# **AAR Interchange Rules Revisions Update For 2019**

**Presented to Chicago Railroad Mechanical  
Association by Nichole Fimple (AAR) on 1/14/19**

# Field Manual of the Interchange Rules

FIGURE B

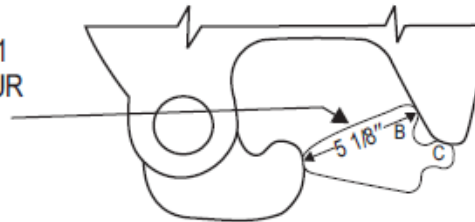
## ■ Updated Rule 16.A.1.b(2):

- (2) Any coupler found out of gage per Figure A must be renewed unless contour can be restored to the provisions of Figure B as measured with Gage No. 25623-1 with application of knuckle and/or knuckle lock.

THE CONTOUR IS ACCEPTABLE WHEN THE GAGE CANNOT BE PASSED VERTICALLY THROUGH THE CONTOUR IN THE POSITION SHOWN WITH POINTS B AND C CONTACTING GUARDARM WITH THE KNUCKLE IN ~~FULL~~ PULL POSITION.

FIGURE B

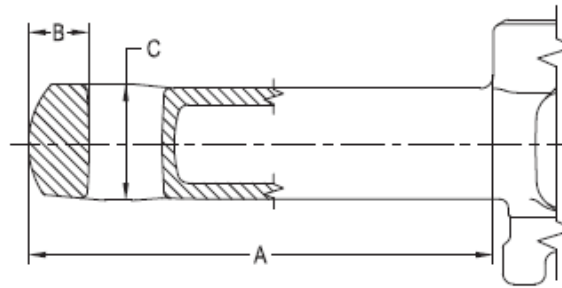
- Removed Rule 17.A.1.b and Figure A and renumbered accordingly.
- Inserted New Rule 17.A.2.a and Figure B and renumbered accordingly.
  - a. When coupler is removed for any reason, measure coupler shank length, rear wall thickness, and butt thickness. Coupler must be replaced if any measurement is less than shown in table for Figure B.
- Reference: C-13240, 11/14/18

## ■ Inserted New Rule 17 Figure B:

Coupler Type	Min Shank Length "A" (inches)	Min. Rear Wall Thickness "B" (inches)	Min. Butt Thickness "C" (inches)
All E68, SE68, SBE68, EF511, EF512, and EF526 couplers	35 $\frac{13}{16}$	3	6 $\frac{3}{8}$
All EF525 and EF528 couplers	37 $\frac{13}{16}$	3	6 $\frac{3}{8}$
All EF601 couplers	45 $\frac{13}{16}$	3	6 $\frac{3}{8}$
All E69, SE69, SBE69, EF811, and EF812 couplers	52 $\frac{13}{16}$	3	6 $\frac{3}{8}$

FIGURE 4

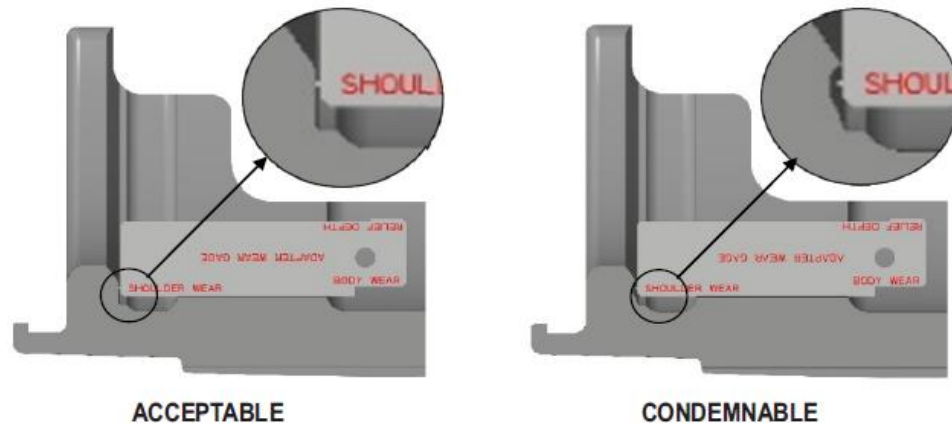
## ■ Updated Rule 37.A.6.c Figure 4:

WORN ADAPTER SHOWING  
CONDEMNABLE THRUST SHOULDER  
WEAR AS GAGE TIP DOES NOT  
CONTACT SHOULDER INDICATING  
MORE THAN .025" ALLOWABLE WEAR  
(THIS WEAR CAUSED BY THRUST  
LOADING FROM END OF ROLLER  
BEARING CUP). CHECK BOTH  
SHOULDERS AT LOCATIONS WHERE  
WEAR IS MAXIMUM.

FIGURE 5  
ADAPTER SECTION

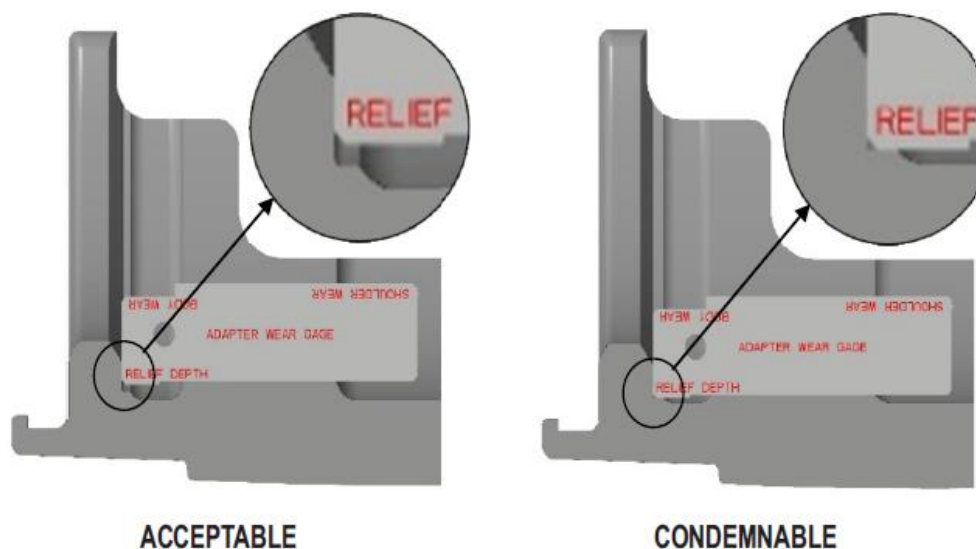
## ■ Updated Rule 37.A.6.d Figure 5:

WORN ADAPTER SHOWING  
CONDEMNABLE BORE WEAR AS THERE  
IS NO CLEARANCE BETWEEN GAGE AND  
MACHINED RELIEF. CHECK BOTH ENDS  
OVER FULL ARC OF ADAPTER BORE.

- Updated Rule 37.A.6.f Figure 6:

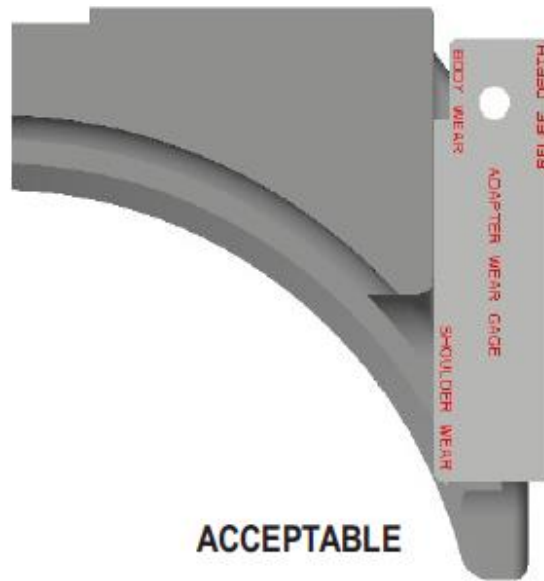
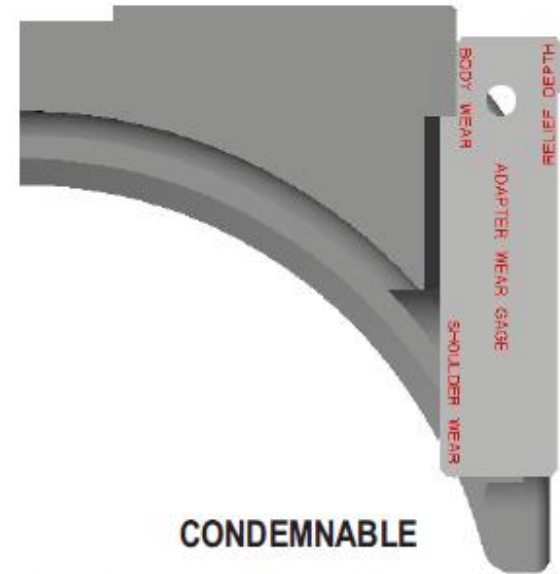
NEW ADAPTER SHOWING HOW GAGE CONTACTS FULLY ALONG SIDE BETWEEN LUGS.

WORN ADAPTER SHOWING CONDEMNABLE BODY WEAR AS THERE IS CLEARANCE BETWEEN GAGE AND BODY OF ADAPTER.

FIGURE A

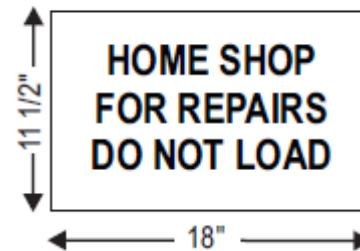
## ■ Updated Rule 80.B.6:

- a. When applied, Home Shop Markings shall be at least 2 inch letters reading “HOME SHOP FOR REPAIRS DO NOT LOAD” and shall contrast with the car body.
- b. When applied Home Shop Decal shall be as shown in Figure A below and shall utilize black letters and black border on green-yellow backgrc
